**Basement Impact  
Assessment Audit**

154 Royal College Street,  
London, NW1 0TA

For  
London Borough of Camden

Project No.  
14006-97

### **Query 3 – Clarification of Foundation depth to Neighbouring Properties.**

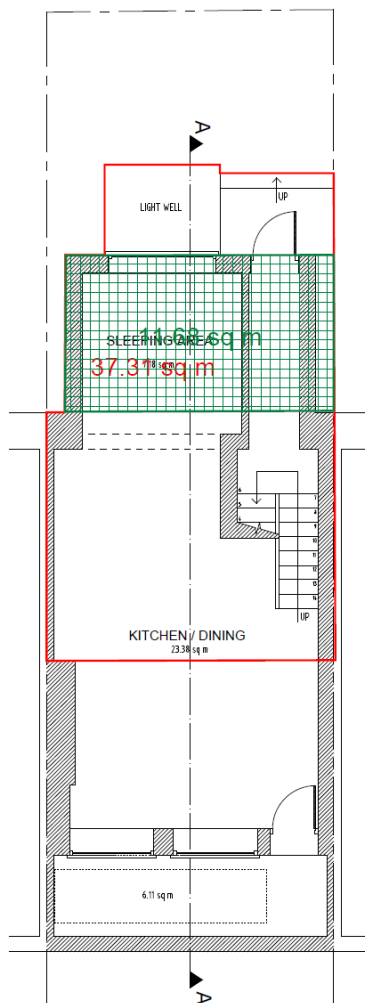
It is apparent from visible construction and historic mapping that the properties of 152,154&156 were/ are a row of terraced houses of same age and construction. No.156 has been historically demolished but No.152 is still present sharing a party wall to the North.

Given that the properties were constructed in the same manner and in the same configuration it would be prudent to presume that the existing foundation provision to No.152 is comparable to that of No.154, with a limited height basement and brick corbelled foundation extending beneath, internal floor levels to the basement are therefore anticipated to be the same/similar

It is understood from a ground movement assessment perspective that this construction represents the greatest level of excavation/ potential source of movement to the properties during the proposed works to No.154, as such has formed the worst-case approach to our assessments.

Figure 2.1 Borehole logs from 152 and 156 Royal College Street (looking north-eastwards)

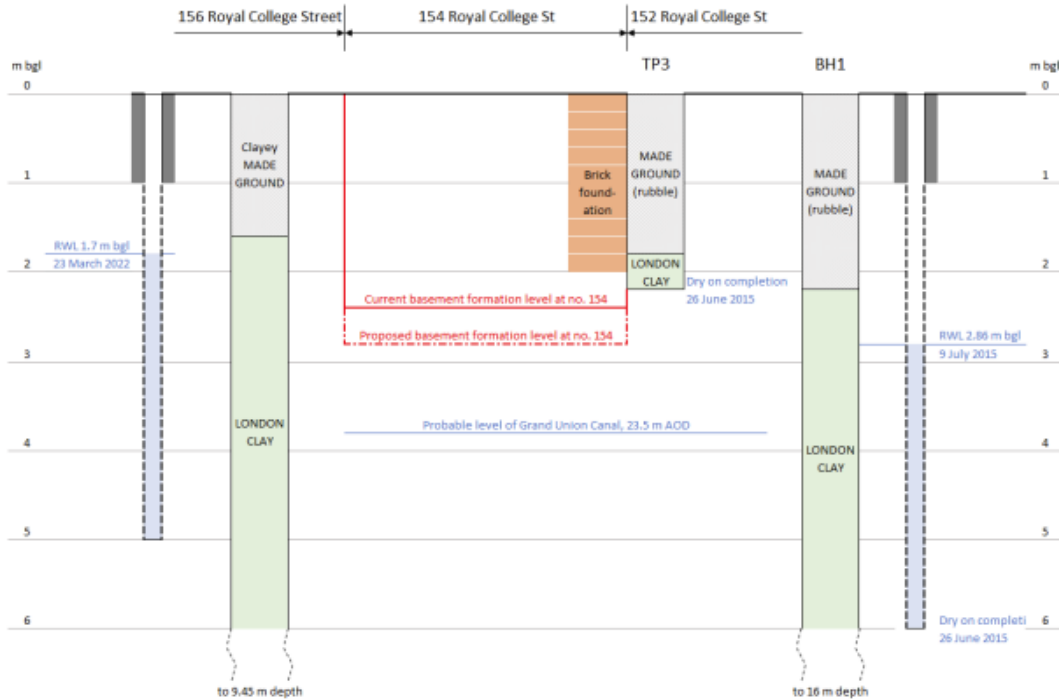
It is understood from adjacent investigations/ borehole logs documented within the BIA that the soil profiles outlined below are anticipated.

It would appear that the made ground to No.152 is associated/ indicative of the historic demolition of the previous basement/ building, as such it would be prudent to presume that the properties of the soils to No.154 are in keeping with the prevailing conditions documented for No.156 and at depth for No.152 underlying the rubble layer.

The following geotechnical parameters are therefore expected/ advised.

Depth	Stratum	Effective Angle of Friction	Effective Cohesion (c')	Bulk Unit Density (kN/m <sup>3</sup> )
0.00 - 1.80m	Made Ground	Conservatively 25°	0 kN/m <sup>2</sup>	20 kN/m <sup>3</sup>
1.80m - 9.45m +	London Clay	Typically, 20°	0 kN/m <sup>2</sup> ; 5kN/m <sup>2</sup> After 5.0m	20 kN/m <sup>3</sup>

### **Query 8 & 9 – Anticipated Structural Movement/ Damage Categorisation**

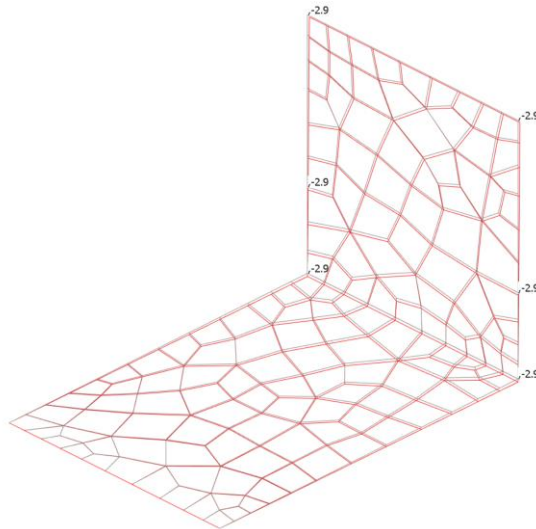
It is apparent from the proposals that there are two basement configurations present to the development, these have been discussed individually below for clarity to establish extent of estimated ground movement and subsequent residual damage characterisation in accordance with Ciria C760.

*Vertical Movement (within acceptable tolerances)*

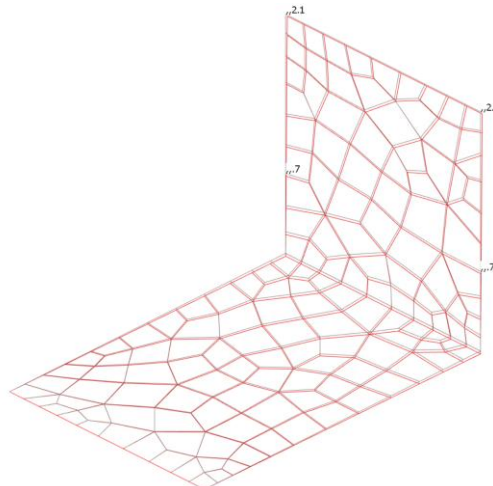
Preliminary analysis of a typical 300mm thick slab/ wall construction using soils parameters outlined in query 6 has been carried out to examine wall displacement/settlements. It should be noted that this construction is to extend into the London Clay stratum underlying the site as such design values have been selected accordingly.

Based on general procedures for Stage 2 Damage Category Assessments outlined in section 6.3 of CIRIA C760 an effective horizontal tensile strain of approximately 0.05% is anticipated. As such the shorter underpin to the main property is likely to result in Damage Category 1 – Very slight in keeping with point 4.33 of Camden Planning Guidance: Basements (2021).

#### New Full Height Basement to Rear

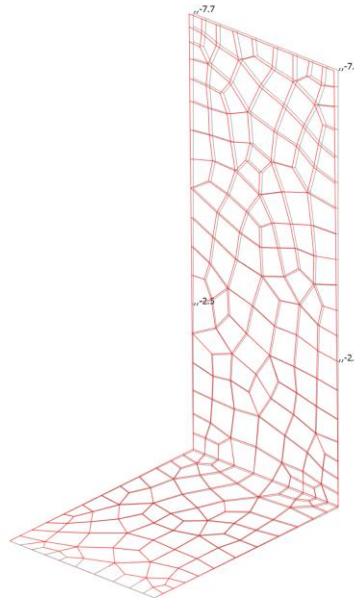
The only full height component of basement excavation/retaining wall is to be located to the rear of both No.154 and No.156, extending through the made ground layer and founding into the London Clay beneath. An assessment has been made on worst case geotechnical parameters for made ground.

The wall detailed above is typically remote from the foundations of the adjacent, any horizontal/ vertical movement will therefore have minimal impact to the rear garden and will not be of significance to the structures onsite.

#### Vertical And Horizontal Movement from Underpin Installation

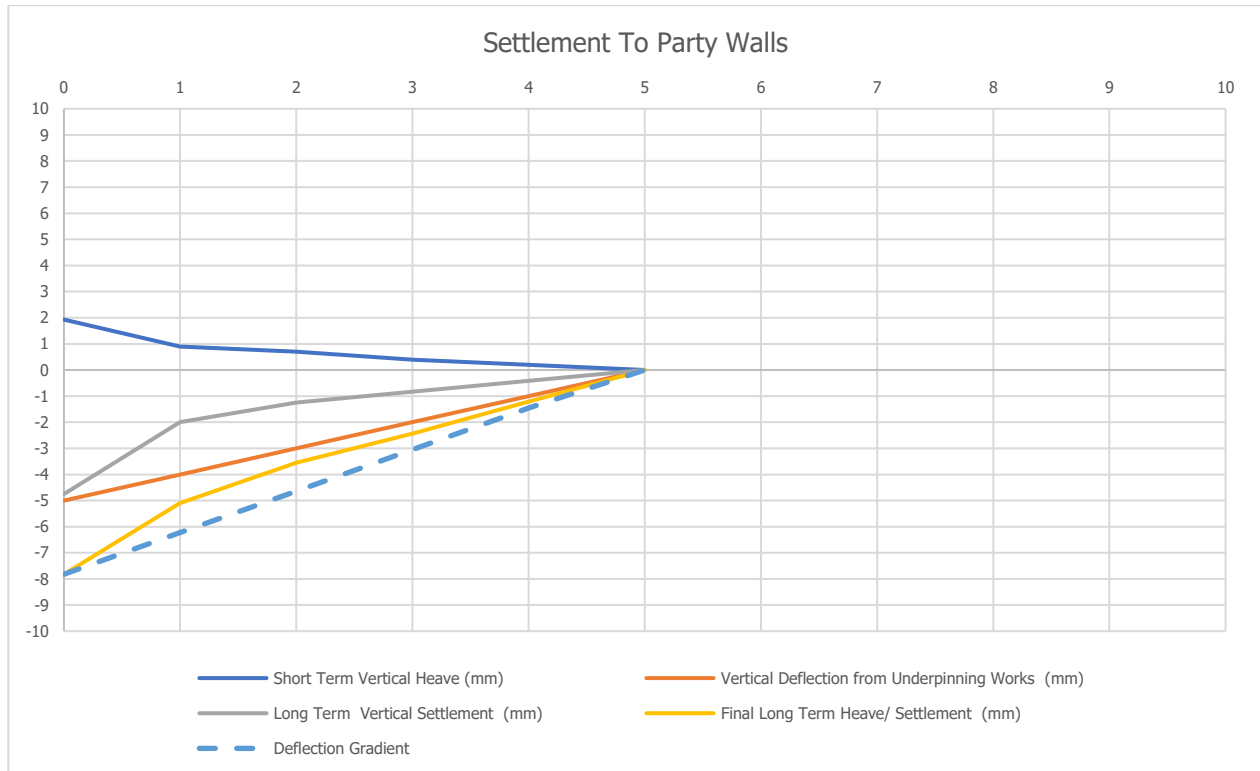
Underpinning will take the form of stiff reinforced concrete walls with limited potential for deflection as highlighted on sheet 6 &7 of this report. However, it is recognised that any deflections that do occur will likely result in surface settlements with may impact neighbouring properties.

It is therefore advised to make a 5.0mm additional allowance to both vertical and horizontal settlements in consideration of ground movements, in keeping with the single stage underpinning methodology.

It should be noted that the presence of existing basement to the adjacent properties limits the excavation depth to approx. 1.0m, this will likely further restrict movements.

**Summary of ground Movements and Corresponding Damage category (152&156 Royal College Street)**

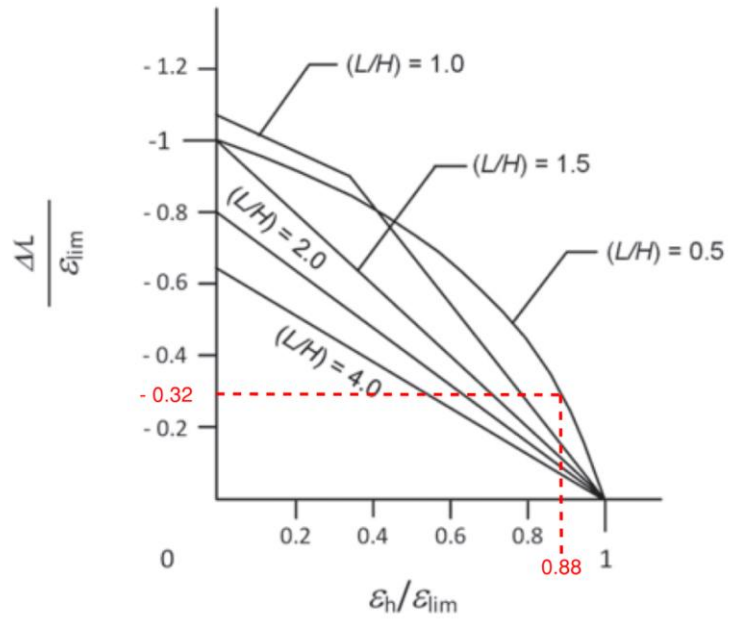
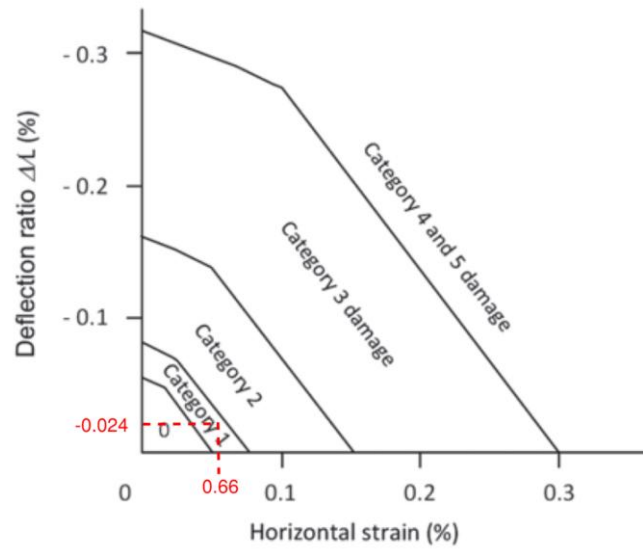
A review of the structures adjoining the site indicate that the most susceptible properties to ground movements associated with the works are the neighbouring properties of 152& 156 Royal College Street.

From analysis the following settlement graph demonstrates the anticipated soil movements within a 5.0m susceptible zone to the excavation/basement construction relative to each party wall line. Given that 154 is a mid-terrace property with similar construction present each side, similar movements would therefore be anticipated to each side.

<b>Adjacent Property</b>	<b>152 Royal College Street</b>	<b>156 Royal College Street</b>
Building Width – L (m)	5.00	5.00
Building Height – H (m)	10.50	10.50
L/H = 0.476	0.50	0.50
Max Deflection	0.012	0.012
$\Delta L$ (%)	0.024	0.024
$\epsilon_{lim}$	0.075	0.075
$\Delta/L/\epsilon_{lim}$	0.32	0.32
Length to Negligible Horizontal Movement (4x)	4	4
$\delta h_{max}$ (m)	0.004	0.004
$\delta h$ (m)	0.0021	0.0021
$\Delta h/L$ (%) = $\epsilon h$	0.10	0.10
<b>Damage Category</b>	<b>&lt;1</b>	<b>&lt;1</b>
